VILLAGE OF DOWNERS GROVE
 Report to the Village

| 2001 63rd Street - Planned Unit Development Amendment, Special Use and Plat of Subdivision | Stan Popovich, AICP Director of Community Development |

**VILLAGE OF DOWNERS GROVE
REPORT FOR THE PLAN COMMISSION
FEBRUARY 5, 2018 AGENDA**

| SUBJECT: | TYPE: | SUBMITTED BY: |
|---|---|---|
| 17-PLC-0041 2001 63 rd Street | PUD Amendment, Special Use and Plat of Subdivision | Rebecca Leitschuh, AICP Senior Planner |

EAST ELEVATION

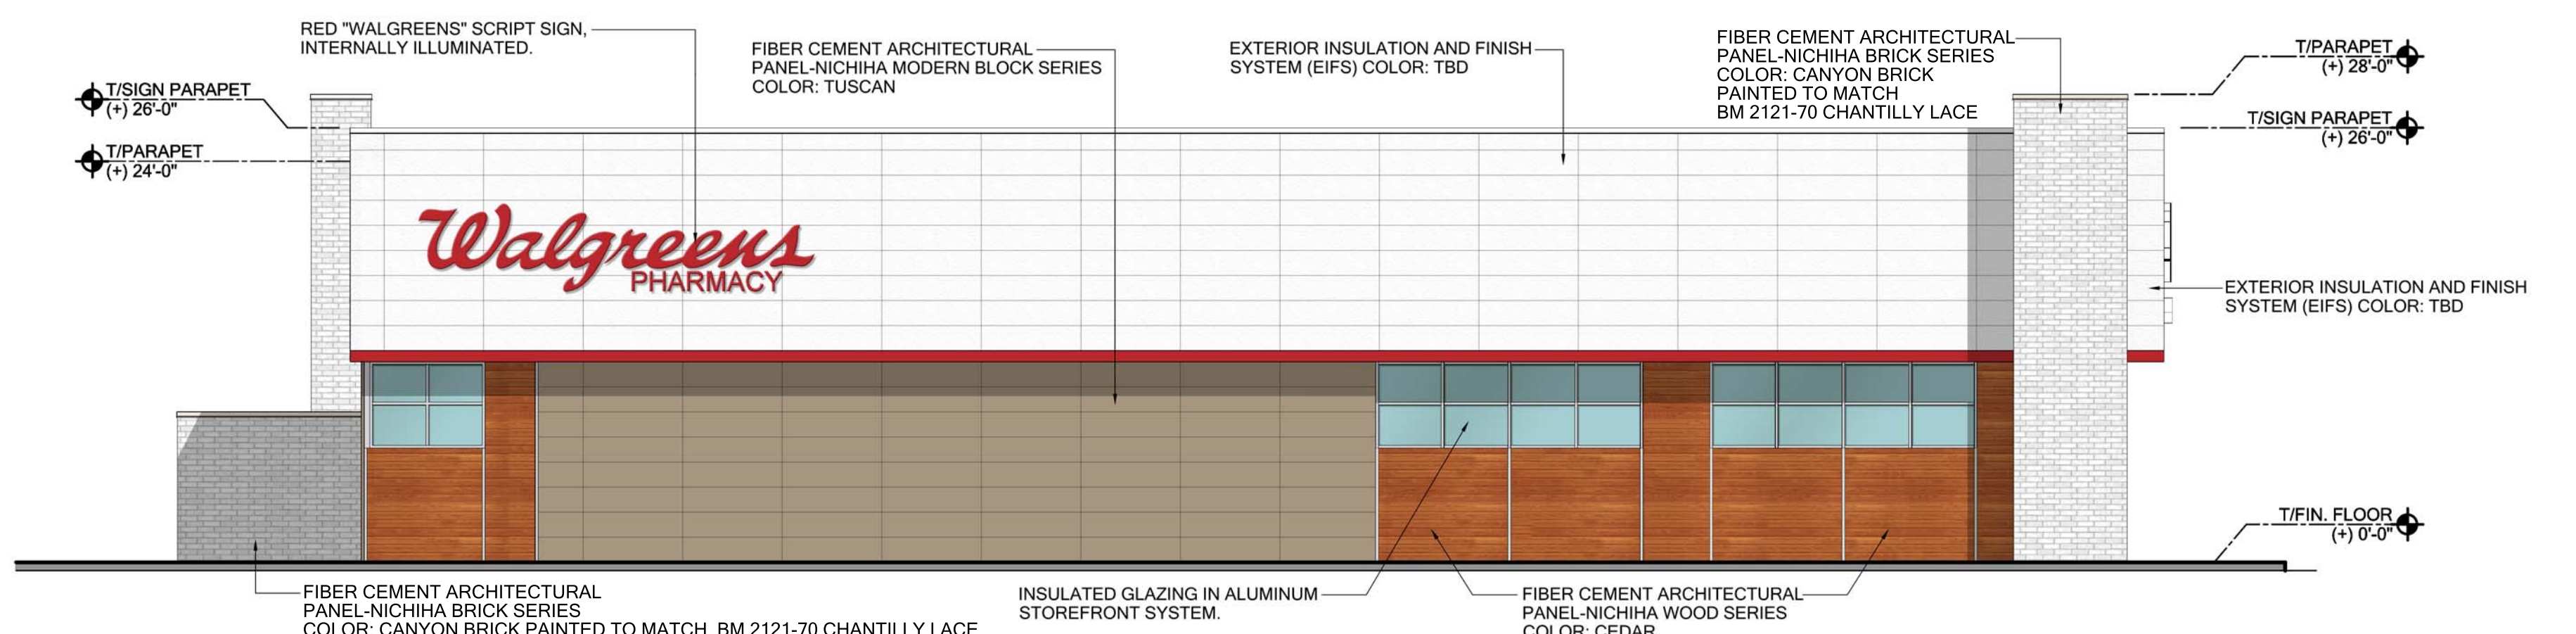
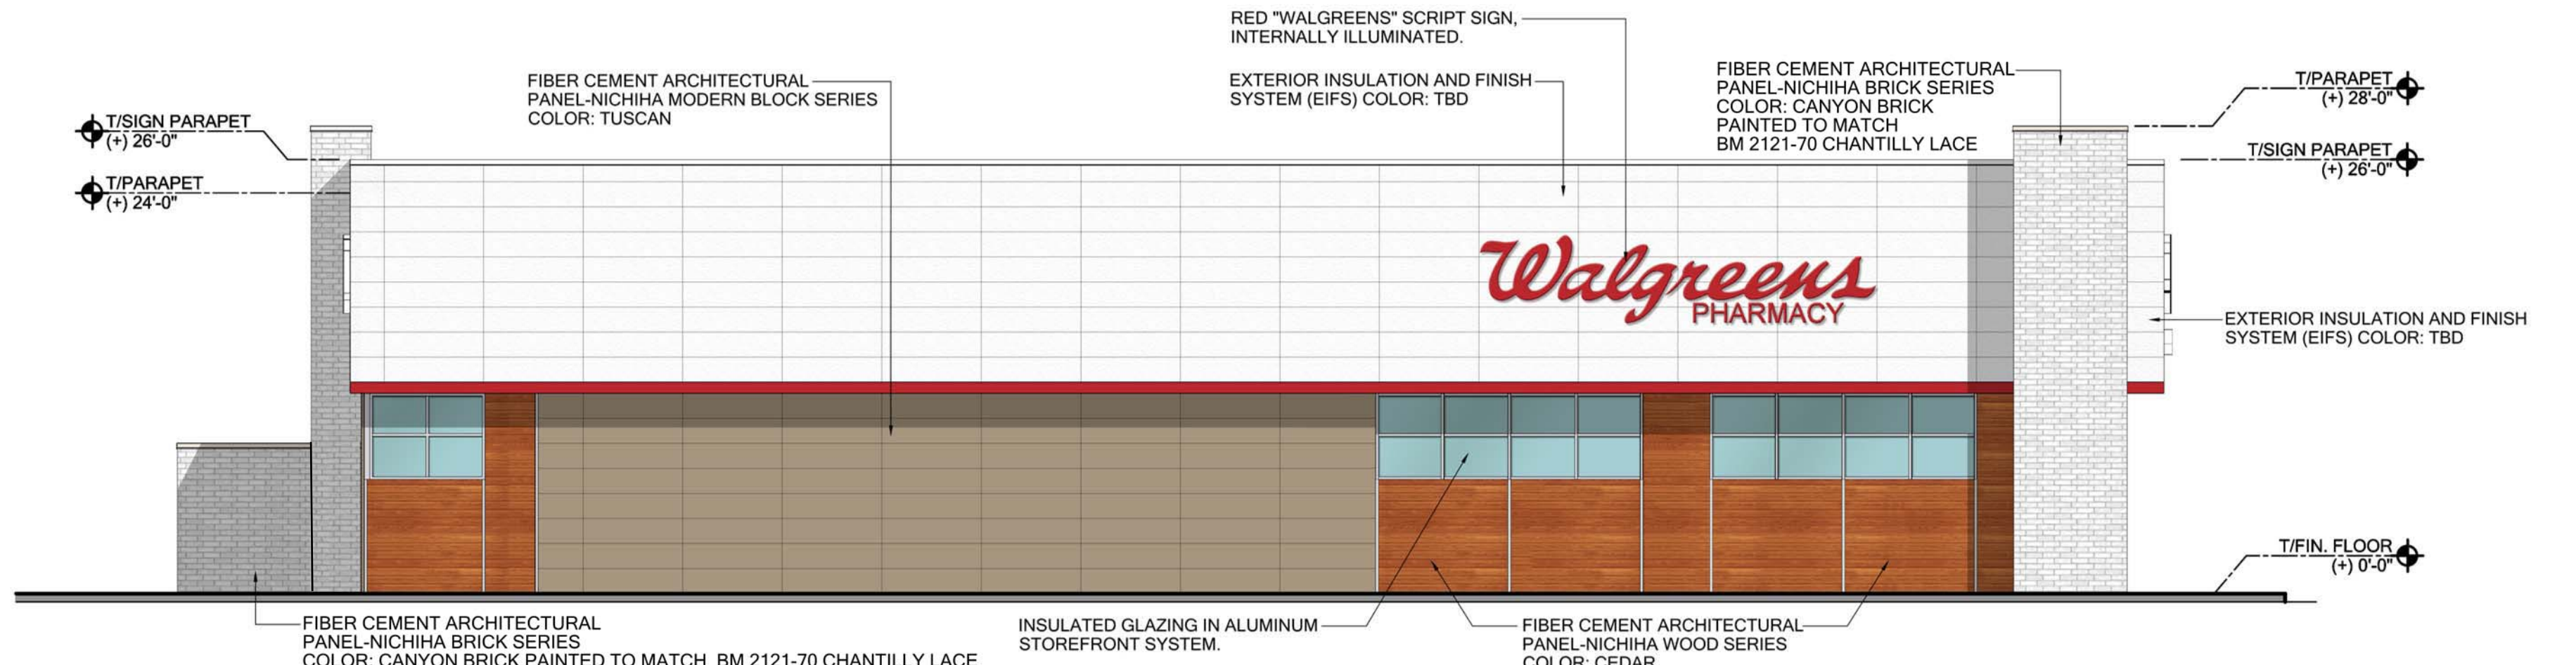
Staff recommends that condition #6, which requires the building design feature be extended across the entire length of the roof-line facing Woodward Avenue, remain. Staff believes the extended design feature creates a more attractive facade facing Woodward Avenue.

The Woodward Avenue (east) elevation continues to wrap the corner with wood panels, windows, and the white EIFS overhang. Staff requests a condition be made to extend the EIFS design element across the entire length of the eastern wall so as to bring greater design detail to the east elevation. A vertical pier, identical to the one on the western elevation, intersects the horizontal planes. The dumpster enclosure, while in a street yard, is designed to complement the building, incorporating the same fiber cement panel system.

Revised east elevation
